Title: VNX Product Family Updates

Date: July, 2013

Scope: This bulletin applies only to the following lonpure CEDI models: IP-VNX50-1, IP-VNX50-2, IP-VNX50-3, and IP-VNX55-2

Purpose: The purpose of this service bulletin is to inform the field sales and service organization of evolutionary changes to the VNX CEDI module product line and to clarify differences between the old and new modules.

Figure 1 Example with three different modules connected to same pipe manifold

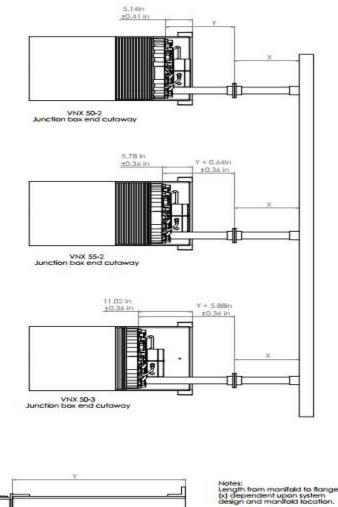
The VNX50-3 is offered as the most economical replacement for a VNX50-1 or VNX50-2 where plumbing connections are made to the fixed end only, and thus the location of the floating end is not important. Additional pipe length will be required for plumbing connections to the floating end (see Figure 1).

Figure 1, below, shows one example of how the EDI module type can affect the length of the module piping adapter in a retrofit situation.
